Series 90

42cc Axial Piston Pump

Service bulletin

Piston improvement

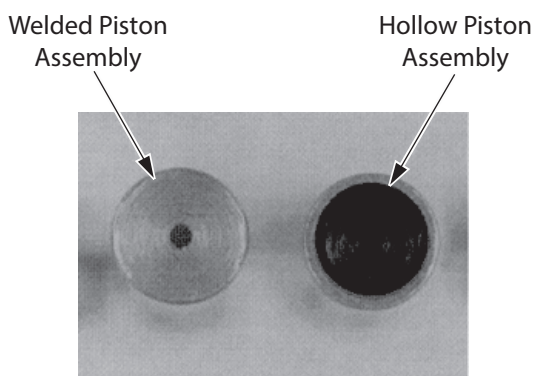
Product Information Bulletin PIB-8801 (March, 1988) announced the incorporation of fabricated (welded) piston assemblies, replacing non-fabricated (hollow) piston assemblies, in the cylinder blocks of all Series 90 pumps and motors. This change increases the overall efficiency of the Series 90 product line.

Since all Series 90 pumps and motors have nine (9) pistons, welded pistons being used to replace hollow pistons during repair **MUST** be install in the cylinder block symmetrically, in multiples of three (3).

Side cover washer elimination

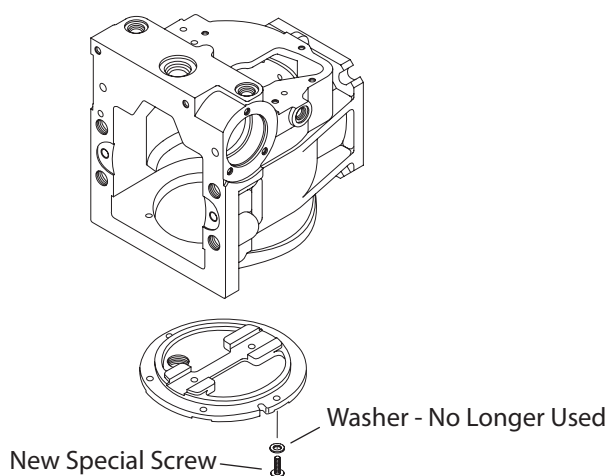
Change took place during the 2nd and 3rd quarter of 1994

Charge pump shaft key change

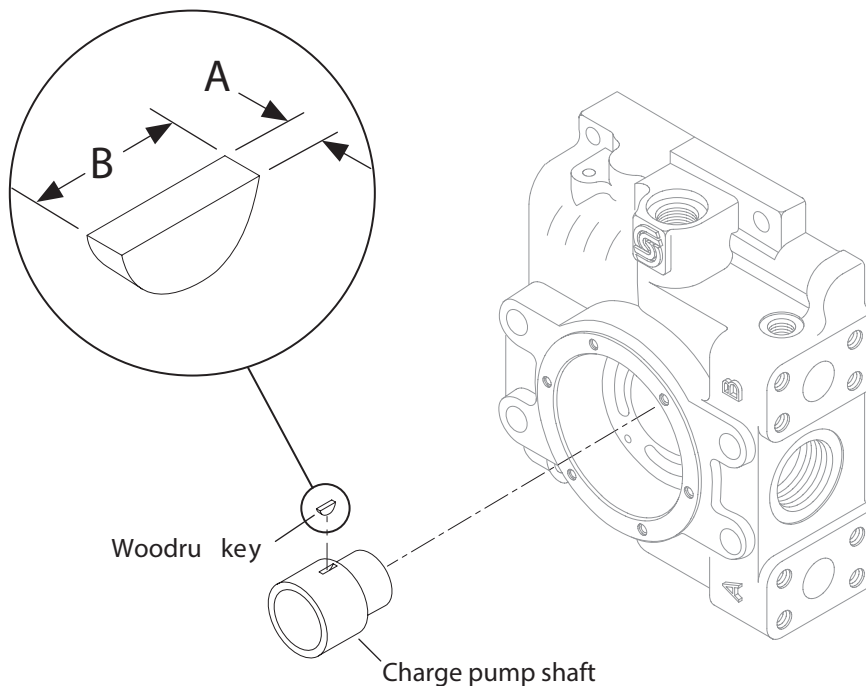
As a product improvement, Sauer-Danfoss has made a design change to the charge pump shaft and woodruff key used on 42 cc variable pumps

This is an interchangeable change within the affected serial number range, if the charge pump shaft and key are replaced together.

Width "A" mm (in)	Length "B" mm (in)
Old key	3.14 (0.1235)	12.70 (0.500)
New key	3.09 (0.1215)	9.53 (0.375)

Manual displacement control (MDC) with DC electric solenoid override

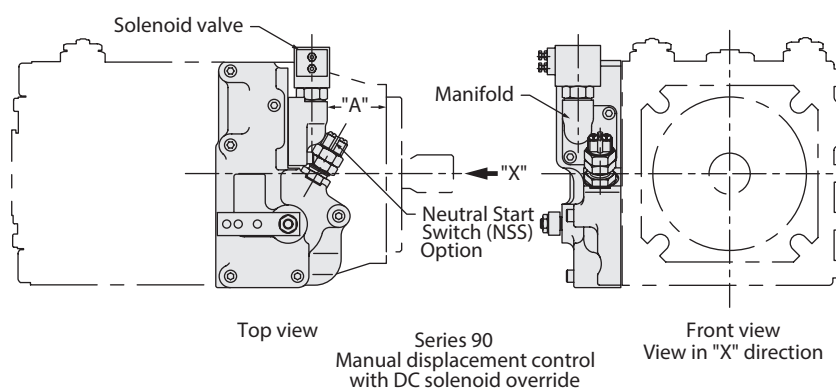
In order to accommodate our European customers, the manifold which attaches to the front of the manual displacement control (MDC) housing is being changed.

The European solenoid valve requires a thicker manifold to provide clearance between the solenoid and the front of the MDC housing. The revised manifold will protrude closer to the mounting flange of the pump, reducing dimension "A" shown in the accompanying drawing by approximately 5 mm [0.2 in]. Please see chart below for specific clearances.

This change will become effective during March of 1995. The old manifold will be obsoleted and no longer available as a service part.

End cap bolt size change

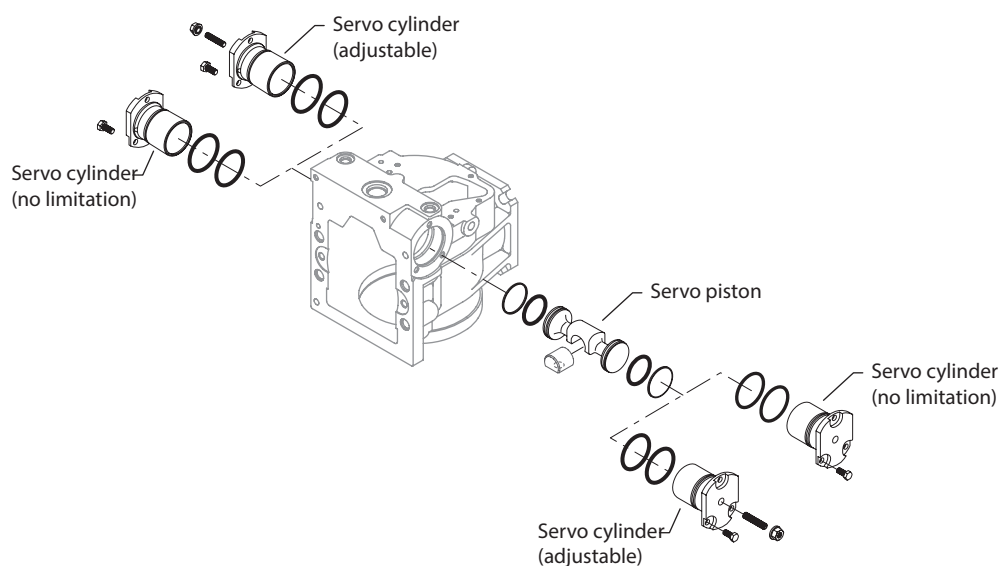
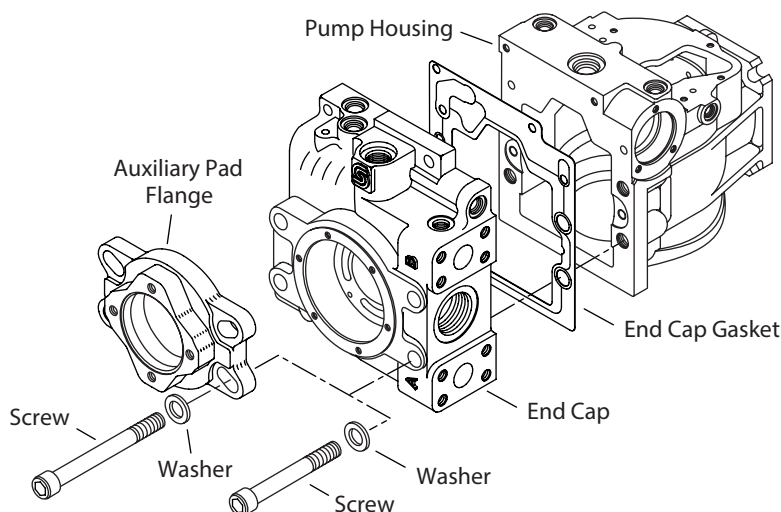
As a product improvement, Sauer-Danfoss is changing the screws that fasten the end cap to the pump housing from M10 to M12.

This change will require a new housing, end cap gasket, end cap, auxiliary mounting pad flange, and screws.

The new end cap and gasket can be used the old housing if hardened washers are used with the M10 end cap screws.

Subject Side cover design change

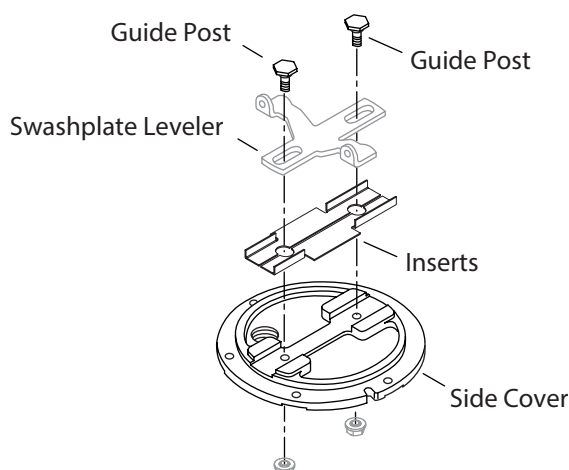
Description As a product improvement, Sauer-Sundstrand is changing the side cover and swashplate leveler (T-Bar) guide post design.

The new design side cover will have two hardened inserts in the machined slot which serves as a guide for the swashplate leveler, and modified guide posts. The swashplate leveler does not change.

Serial numbers Change occurred at serial number N-96-08-xxxxx.

Auxiliary flange charge pump cover

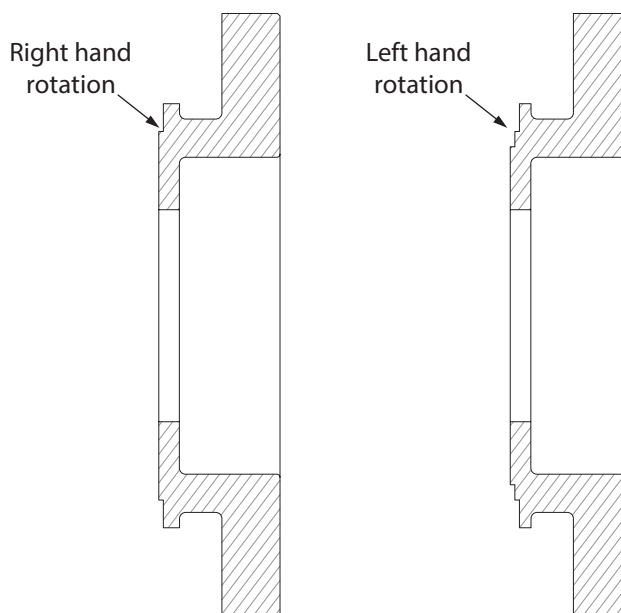
The part numbers of the charge pump covers will not change.

This change became effective at serial number A-05-17-xxxxx

Service Bulletin: SB-2009-074

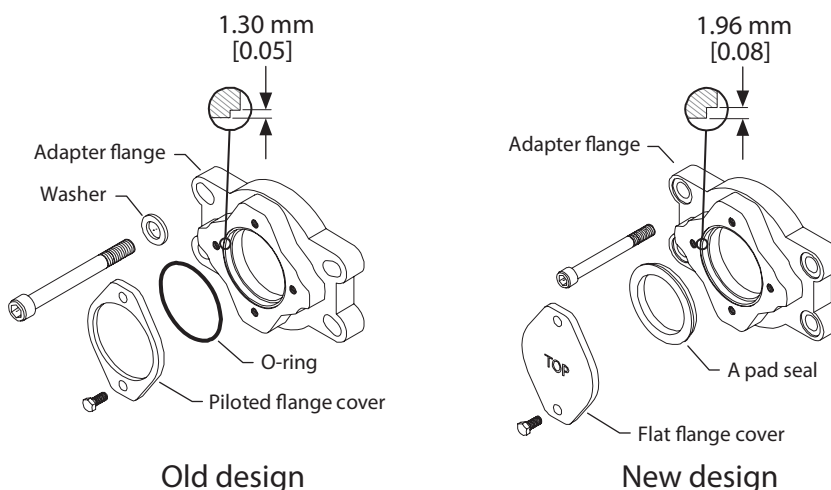
Description Sauer-Danfoss is pleased to announce a design improvement on the SAE A auxiliary mounting flange adapter on its series 90 pumps. The frame sizes affected by this change are 42, 130, 180 and 250cc. All manufacturing locations producing these pumps will be changed to this configuration.

The pumps will now be supplied with the donut style seal and new flat cover, instead of the small O-ring and stepped cover plate (shown in the drawing below).

Serial numbers Change became effective at serial number N-09-30-xxxxx. (20 July 2009)

SAE B auxiliary mounting flange, O-ring seal

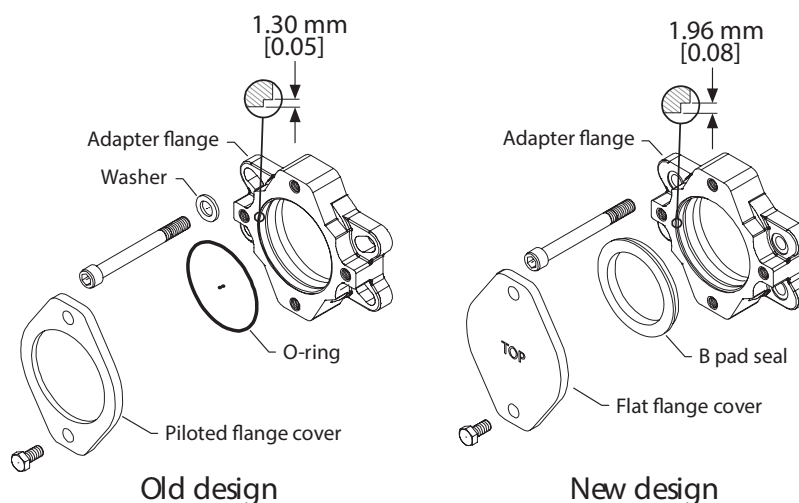
Sauer-Danfoss is pleased to announce a design improvement on the SAE B auxiliary mounting flange adapter on its series 90 pumps. The frame sizes affected by this change are 42, 130, 180 and 250cc. All manufacturing locations producing these pumps will be changed to this configuration.

The pumps will now be supplied with the donut style seal and new flat cover, instead of the small O-ring and stepped cover plate (shown in the drawing below).

Change became effective at serial number N-09-30-xxxxx. (20 July 2009)

Service Bulletin: SB-2009-076

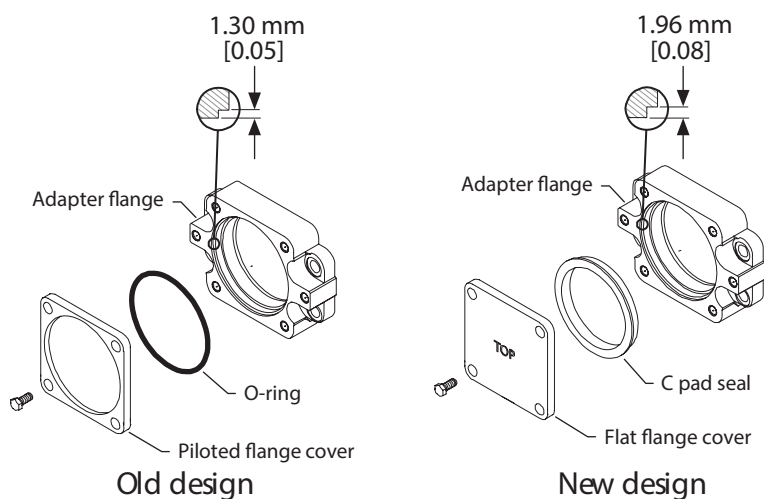
Description Sauer-Danfoss is pleased to announce a design improvement on the SAE C auxiliary mounting flange adapter on its series 90 pumps. The frame sizes affected by this change are 130, 180 and 250cc. All manufacturing locations producing these pumps will be changed to this configuration.

The pumps will now be supplied with the donut style seal and new flat cover, instead of the small O-ring and stepped cover plate (shown in the drawing below).

Serial numbers Change became effective at serial number N-09-30-xxxxx. (20 July 2009)
